Central Zoo Authority

F. No. 19-62/92-CZA(27)(Vol. VII)(M) / 4231

Sub:- Designs for the construction of various enclosures at Assam State Zoo, Guwahati.

The designs for the construction of various enclosures at Assam State Zoo, Guwahati was placed before the 46th Meeting of the Expert Group on Zoo Designing of the Central Zoo Authority held on 3rd January, 2014. After detailed deliberation, the design was approved subject to the following:-

PROPOSED PIGMY HOG ENCLOSURE

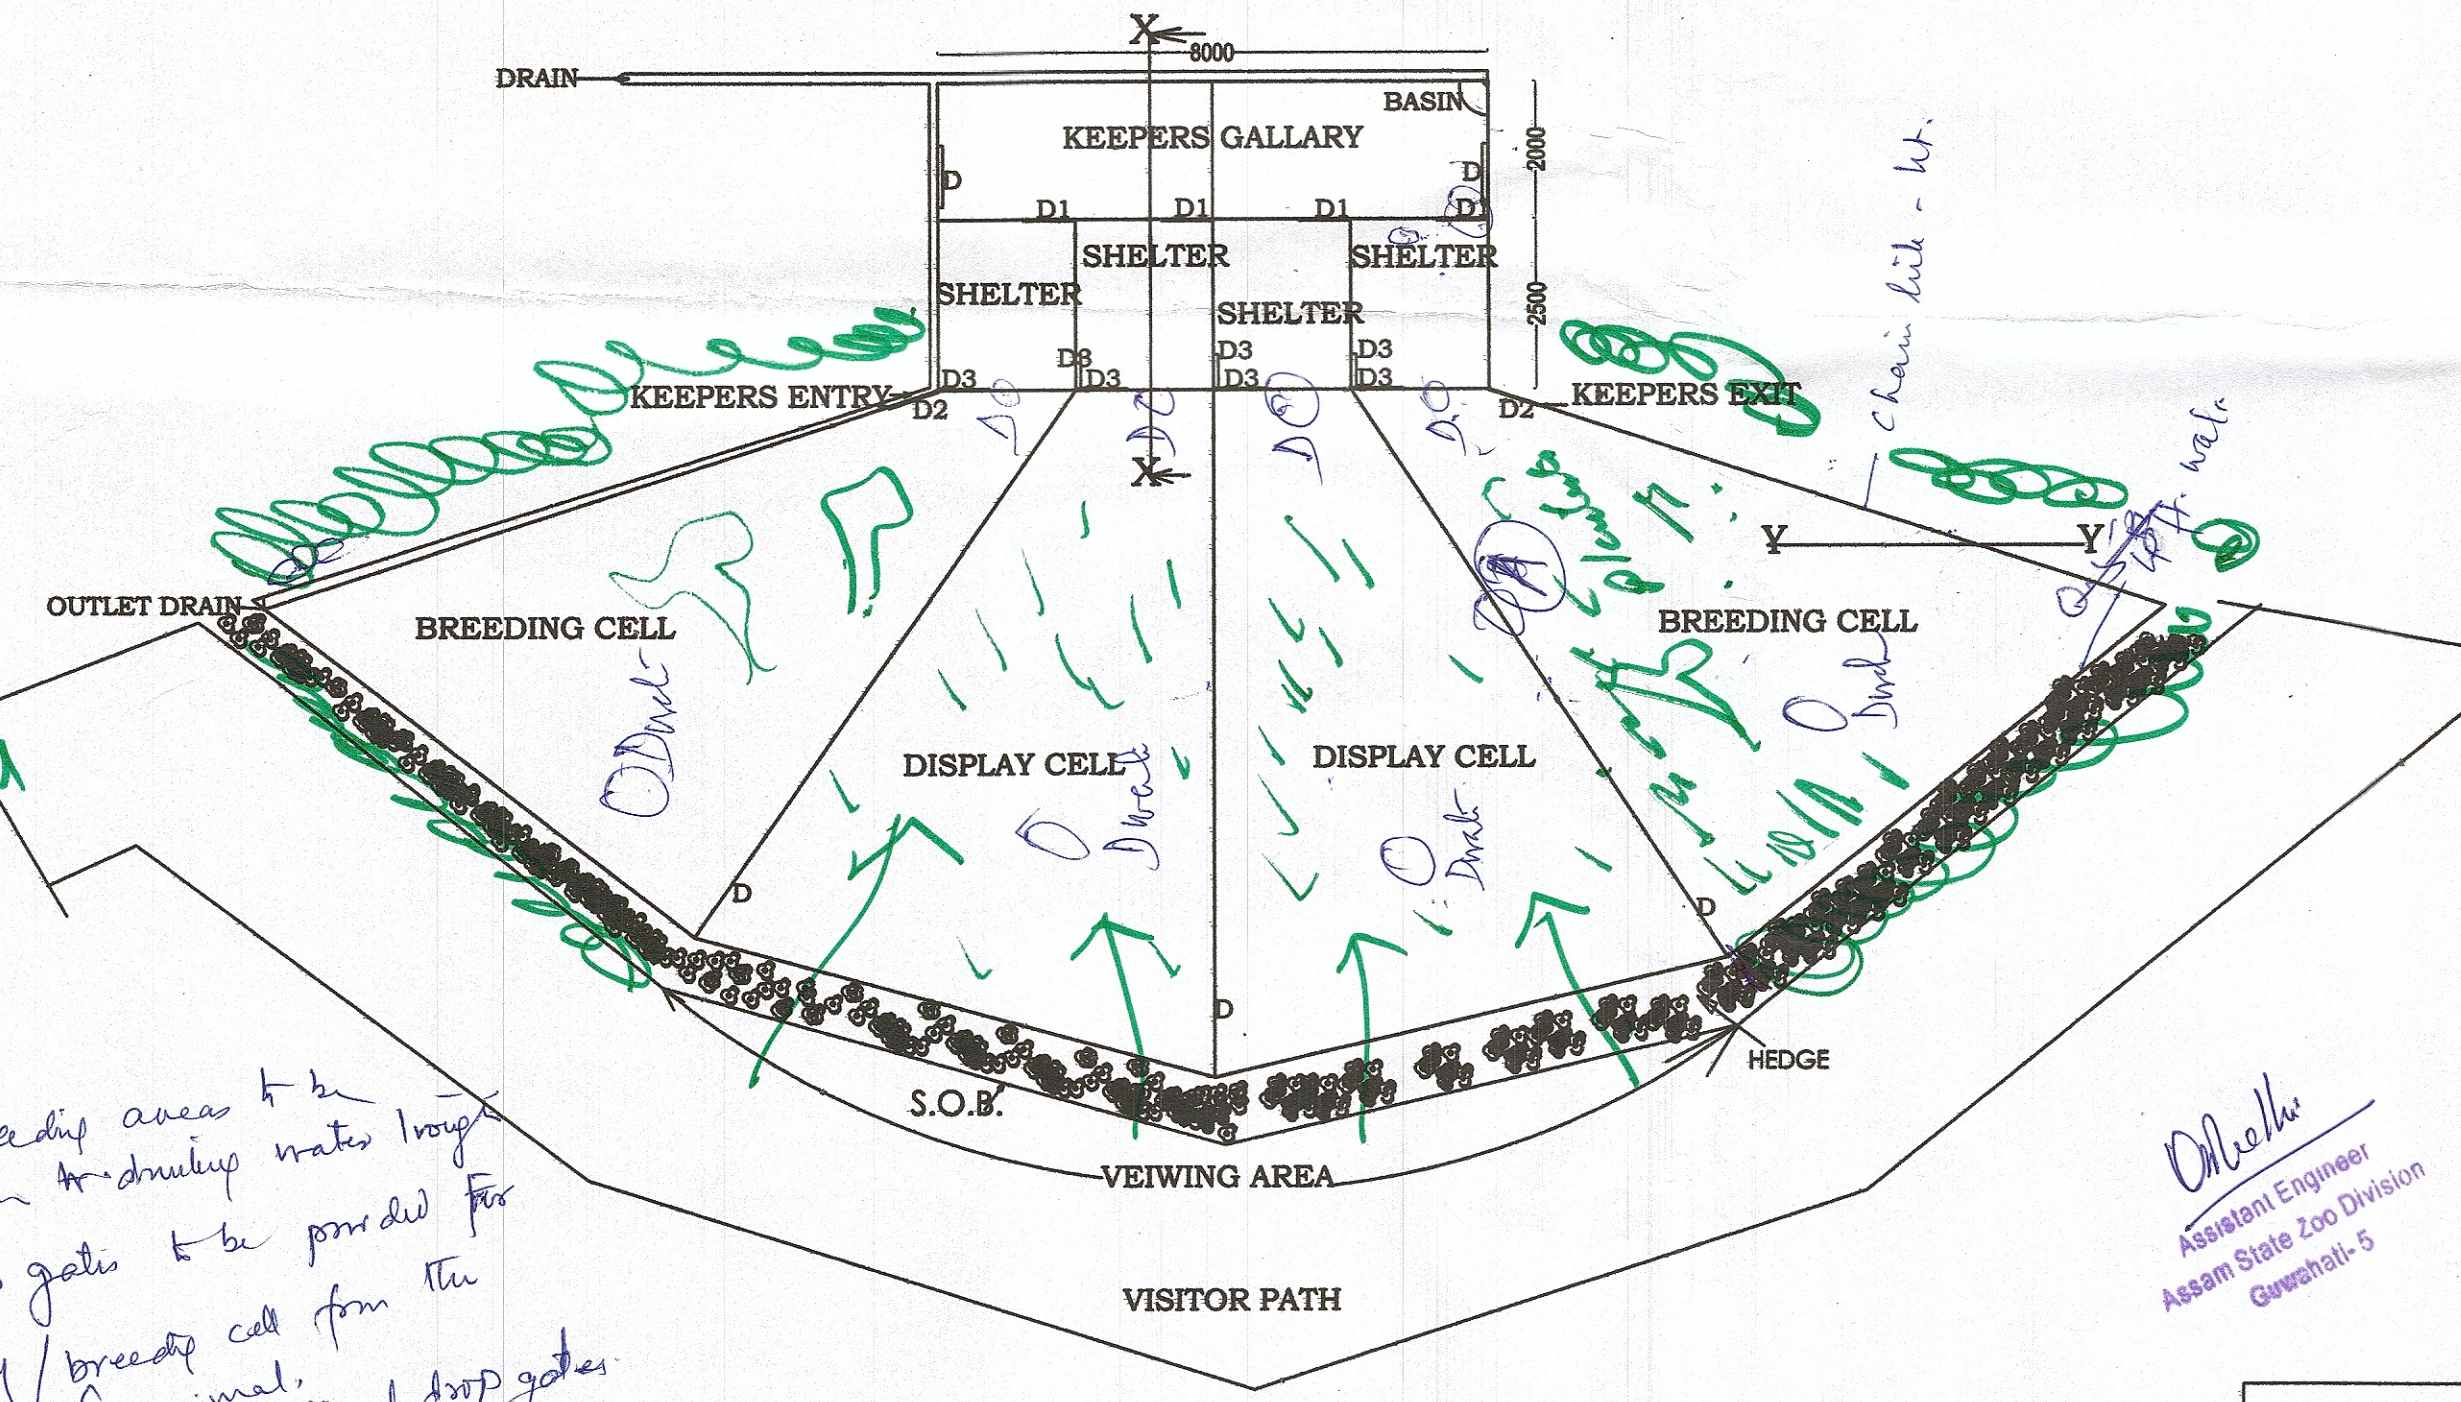
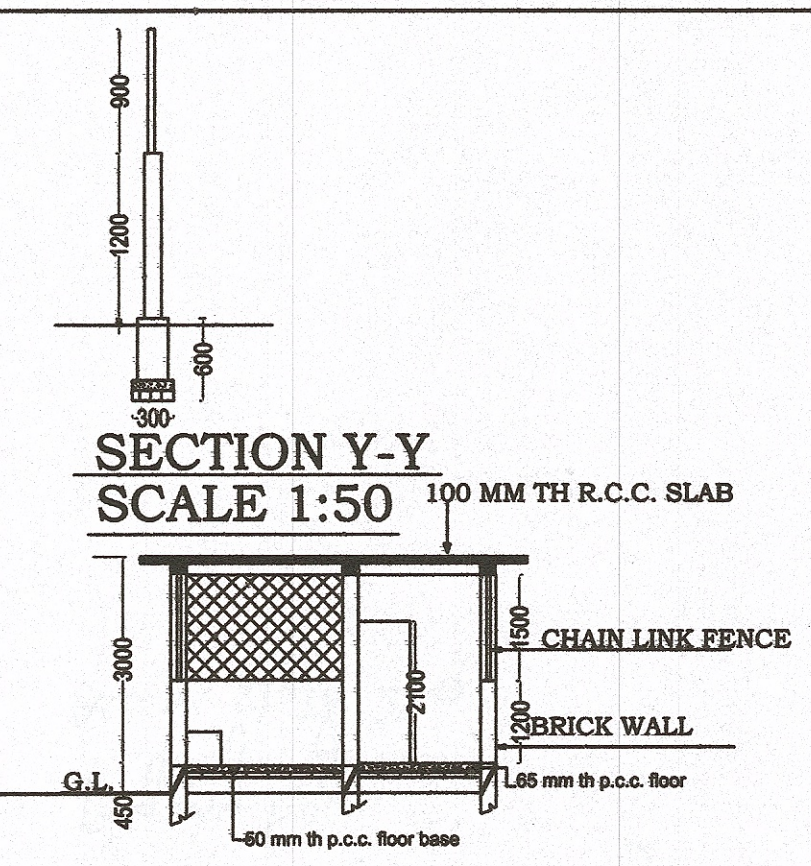
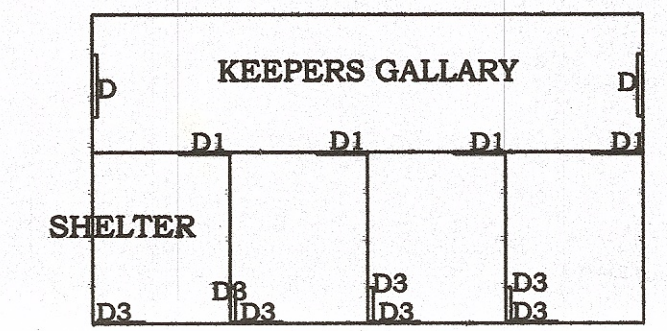
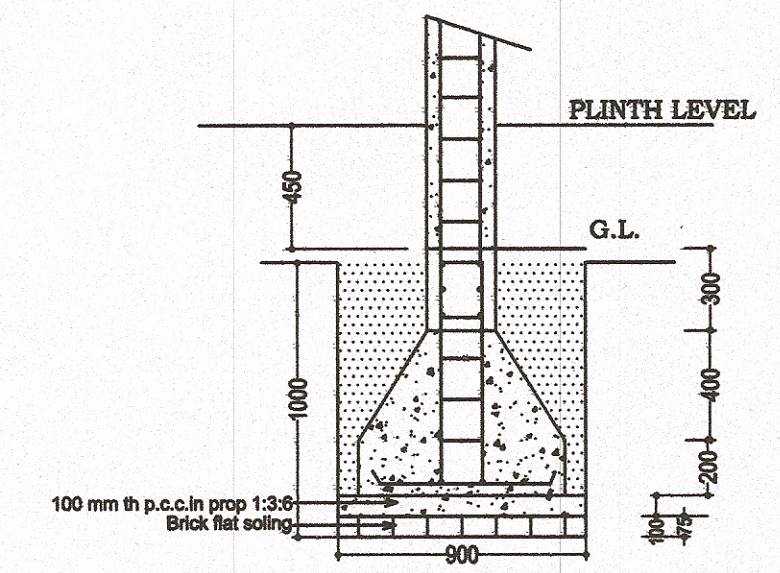
*A-41 off wall
- all inside
- 1/2 chain link down*

*Approved with
changes as follows*

1. Display & breeding areas to be provided with drinking water trough
2. Vertical drop gates to be provided for entry to display / breeding cell from the shelter
3. All entry gates to be vertical drop gates
4. Position between display and breeding area shall be of 0.5m high wall with chain link above
5. Top cover with chain link not required
6. Edge from boundary of breeding cell come into chain link fencing only.
